PHILADELPHIA ELECTRIC COMPANY

July 10, 1981

Re: Docket Nos. 50-277
50-278

Your letter of June 10, 1981, expressed concern over the use of filter systems in the control rod drive hydraulic system (NUREG-0619). In addition, the letter, as quoted below, requested further information regarding the proposed modifications to the CRD system.

Simplified Schematic of Modified CRD Hydraulic System

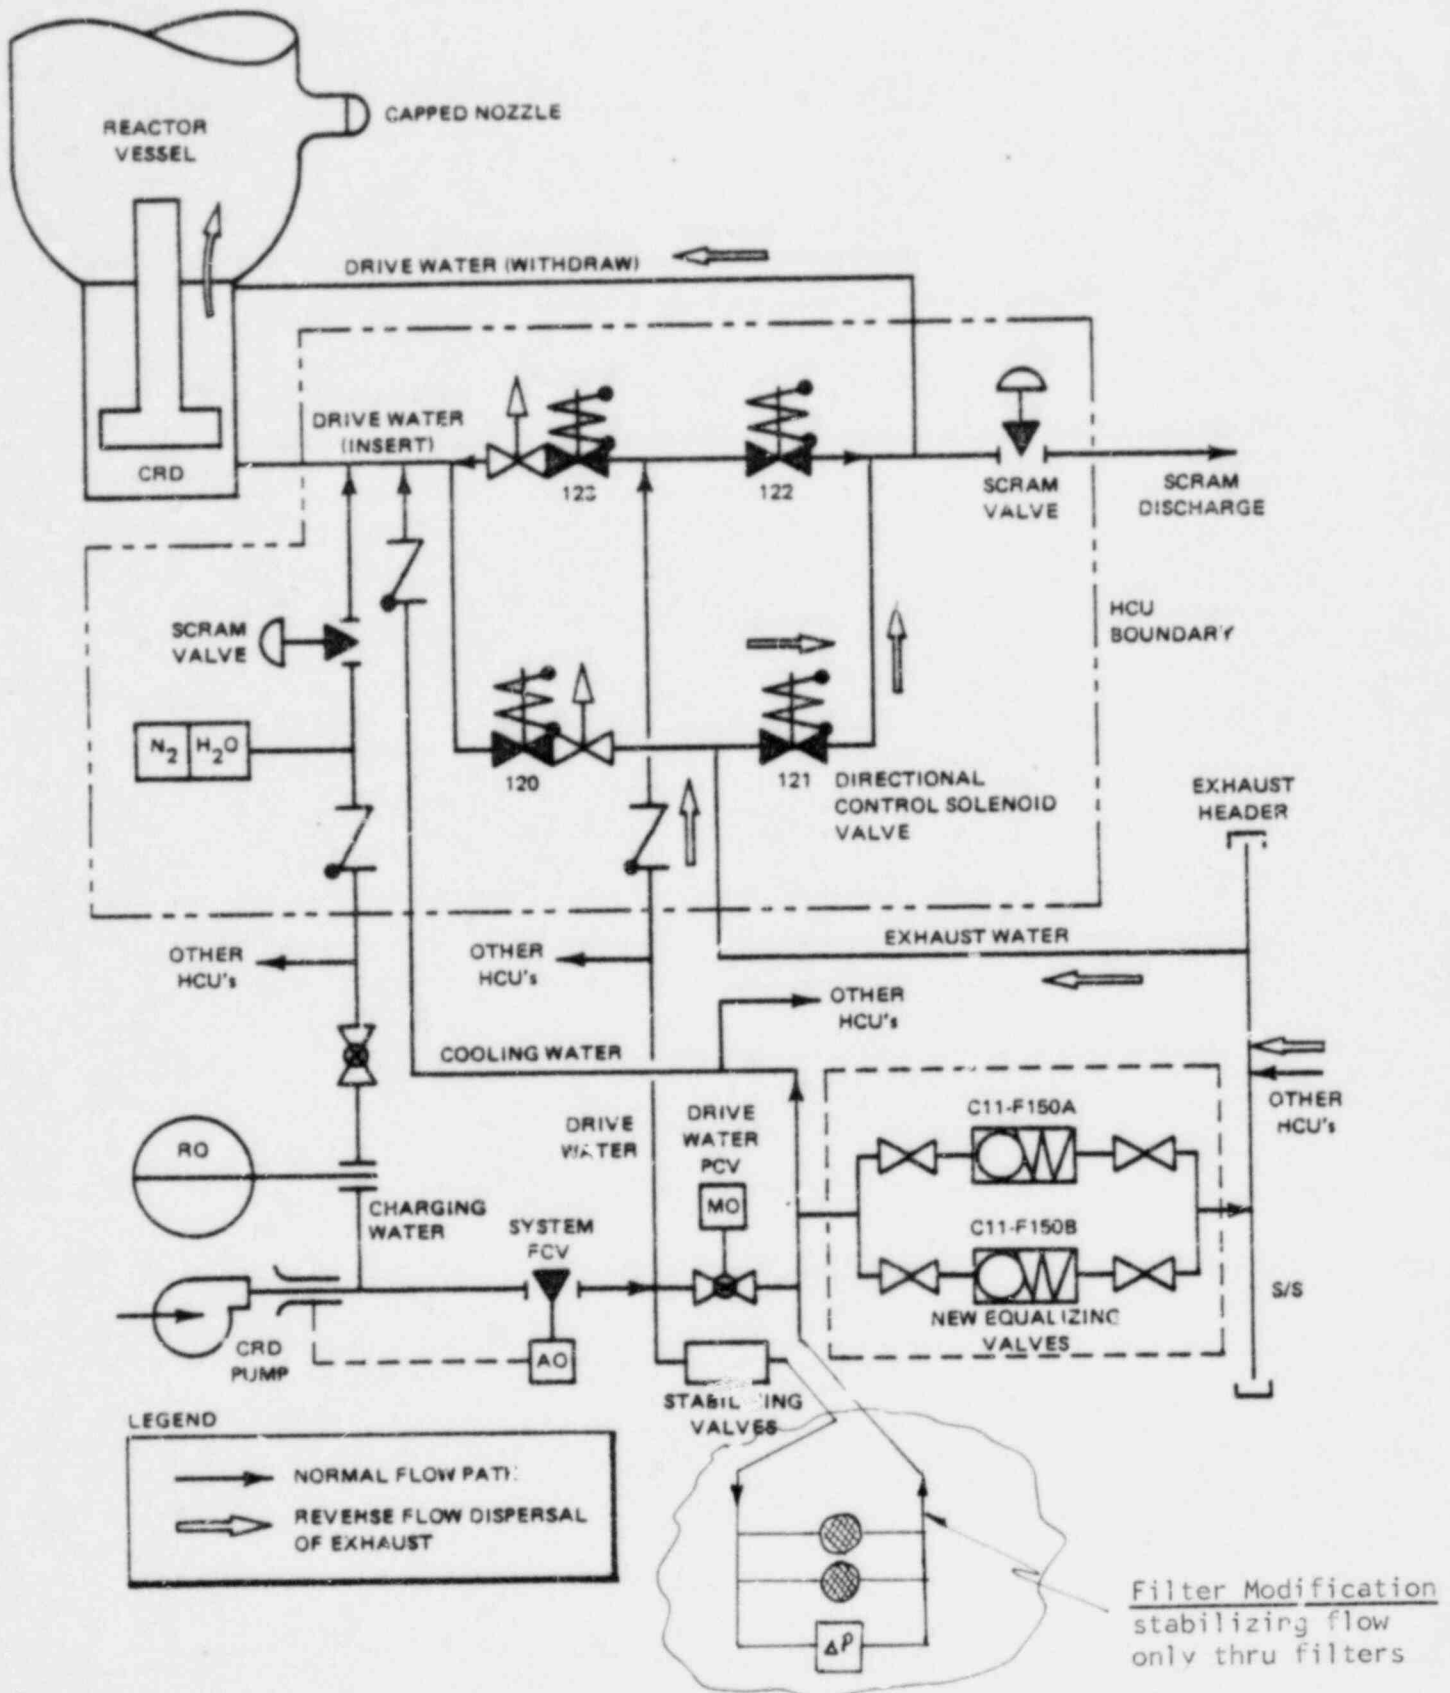
"You have stated that replacement of carbon steel pipe in the flow stabilizer loop is not necessary because of the particular existing system configuration incorporating filters. Our objection to the use of filter systems is contained on page D-6 of NUREG-0619. Please provide justification for continued use of the filters, including minimum particle size, alarm setpoint, location of alarm, procedural changes to incorporate filter maintenance, etc."

We have reviewed the NRC concern over the use of filters in the CRD system, as expressed in NUREG 0619, Appendix D, and conclude that the existing modification is acceptable. The concern is that improperly maintained filters on the cooling

The redundant filters installed per General Electric's recommendation in SIL-200, Rev 1, prevent any carbon steel corrosion products from re-entering the flow stream to the drives via the cooling water headers. The filters are not in the primary path for the cooling water to the CRD's, and therefore cannot restrict the cooling water flow to the CRD's. The attached sketch demonstrates the location of the filters with respect to the main cooling flow and the stabilizing valves.

The filters selected and installed are 50 micron absolute (20 micron nominal) units, equipped with differential pressure alarms set at 5 psi that indicate high filter pressure in the control room. No procedural changes to the normal maintenance of these filters is anticipated.
